CITY OF ALBUQUERQUE

PLANNING DEPARTMENT – Development Review Services

RE: **Cosme Retail
Grading & Drainage Plan
Engineer's Stamp Date 10-12-2016 (File: K11D077)**

GRADING & DRAINAGE PLAN

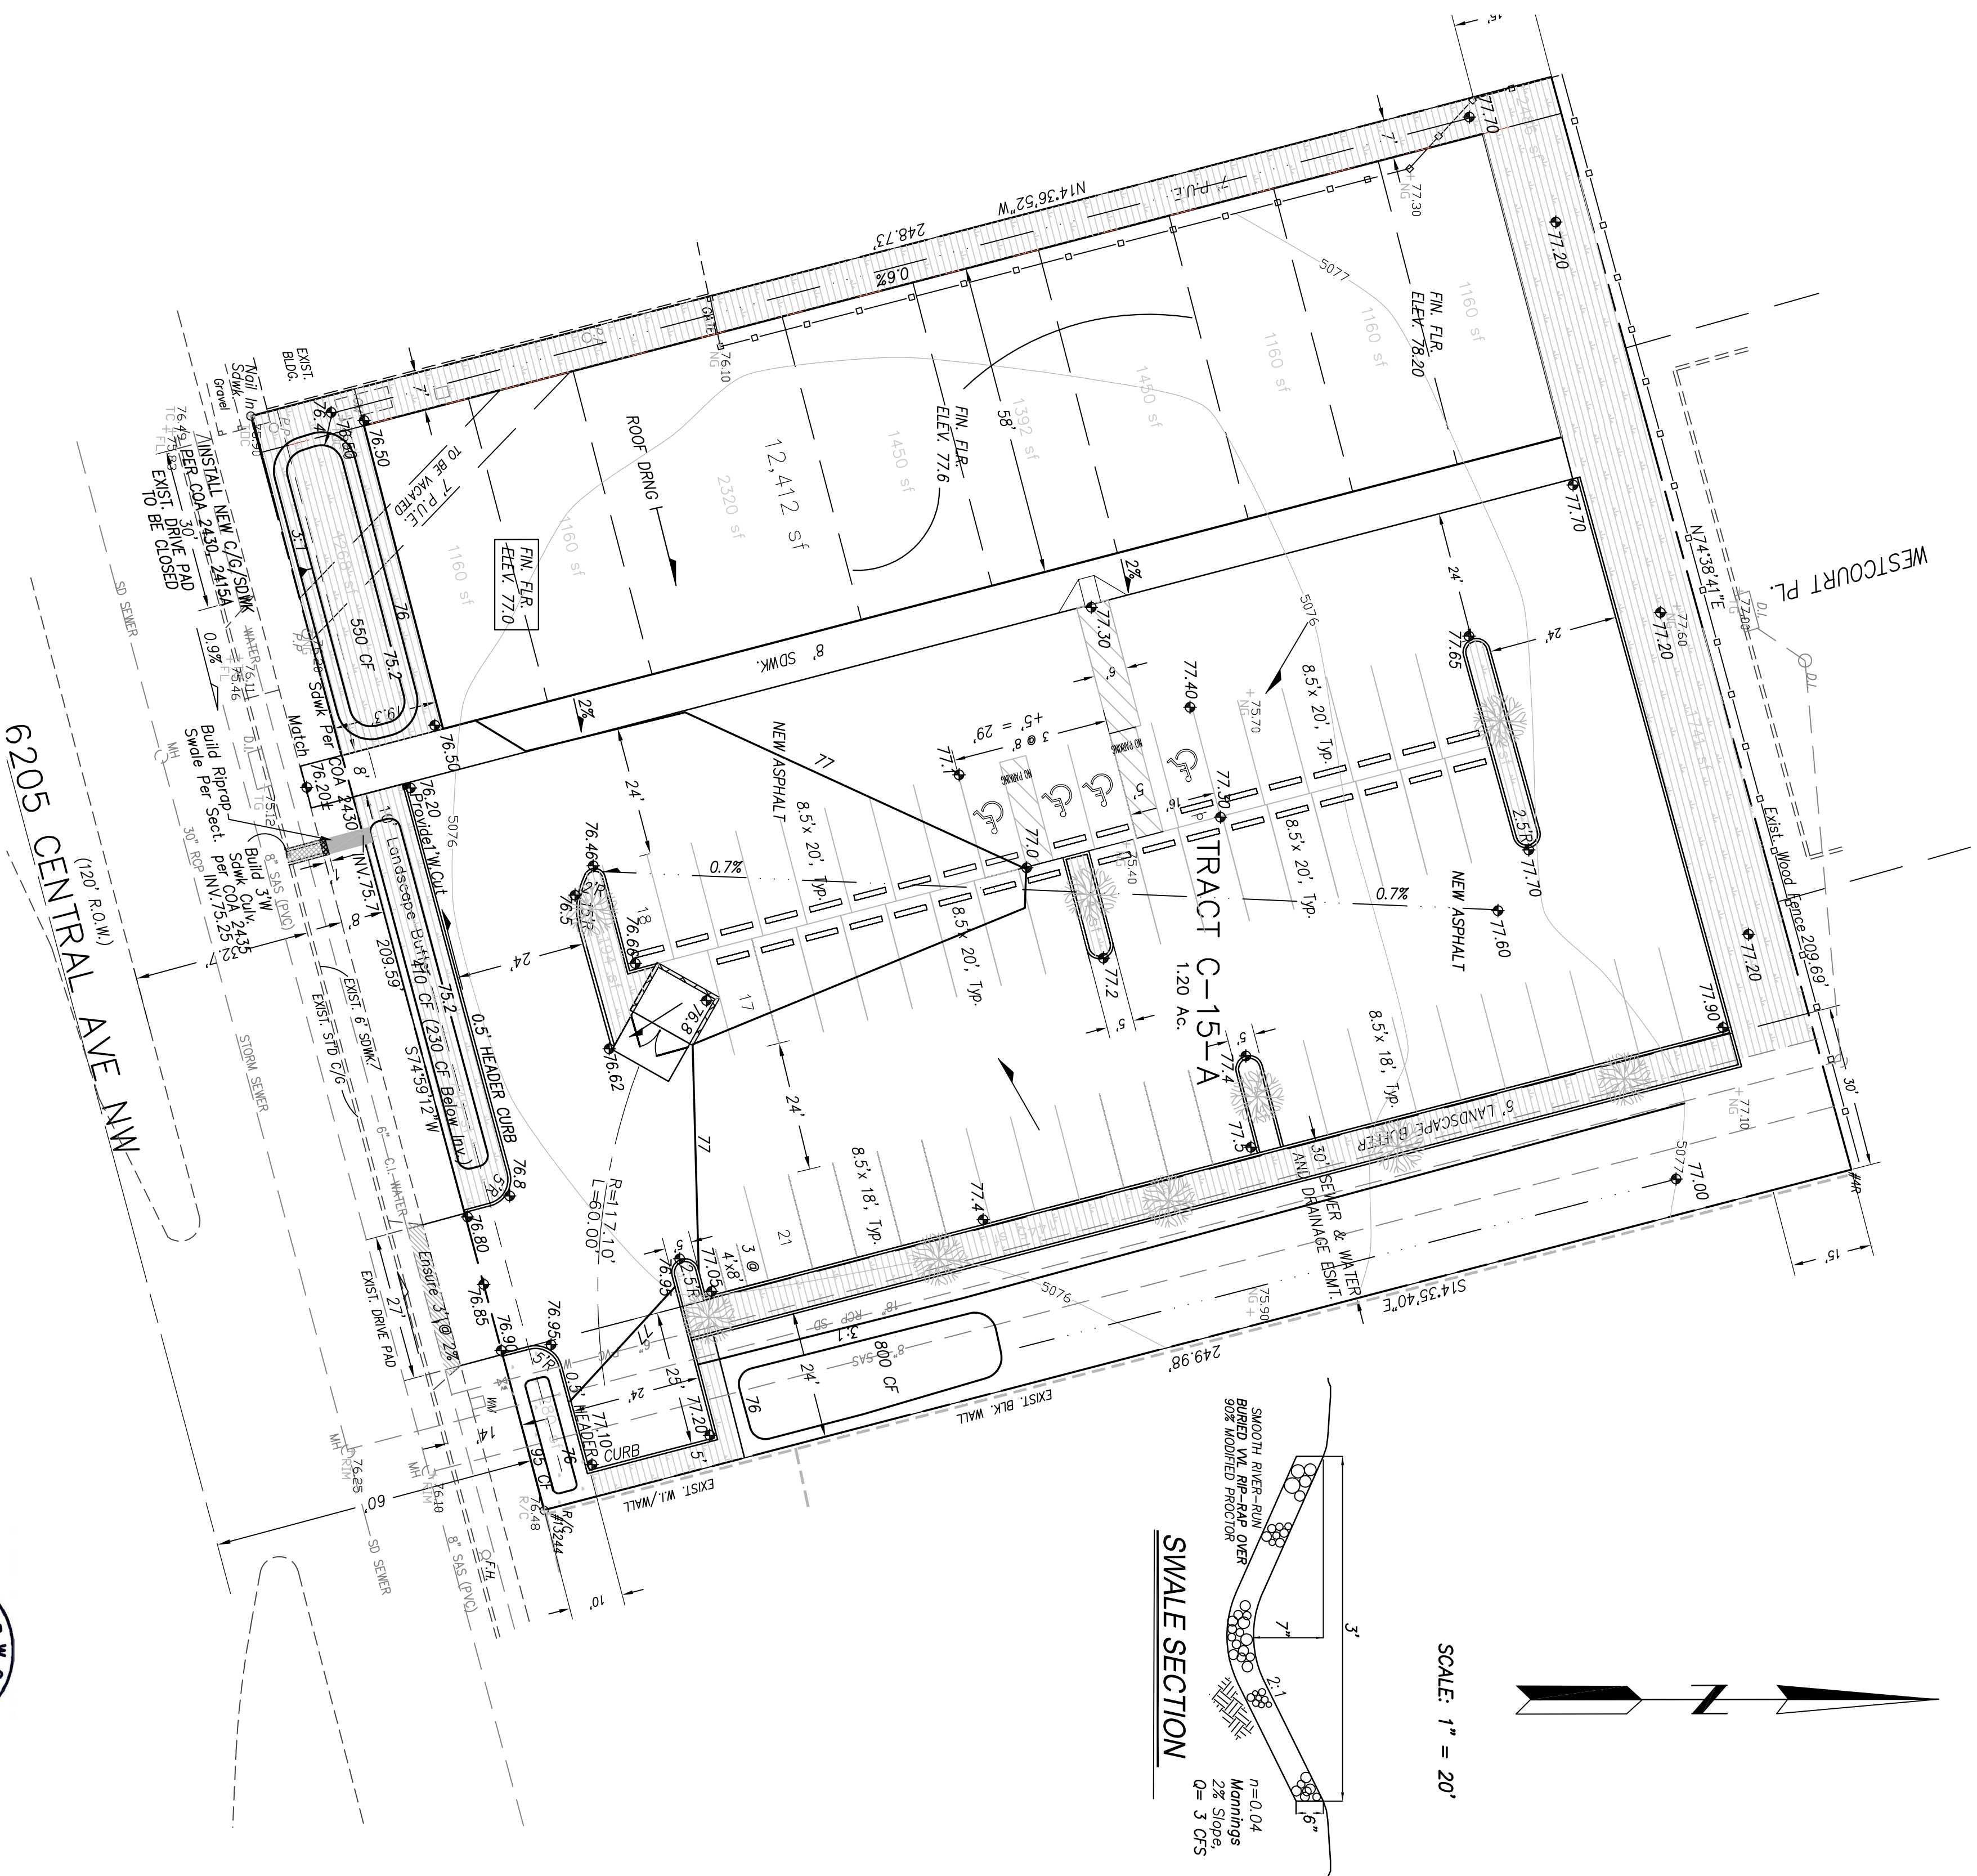
Based upon the information provided in your submittal received 10-14-2016, the above referenced Grading and Drainage Plan is approved for ESC Building Permit. Please attach a copy of this approved plan in the construction sets when submitting for a building permit.

Prior to Certificate of Occupancy release, Engineer Certification per the DPM checklist will be required. A completed floodplain permit will be required prior to sign off for CO.

Please ensure that the Developer/Contractor process an ESC Grading Permit (attached), they can be submitted to Curtis Cherne. An approved ESC Plan will be required to approve the Permit.
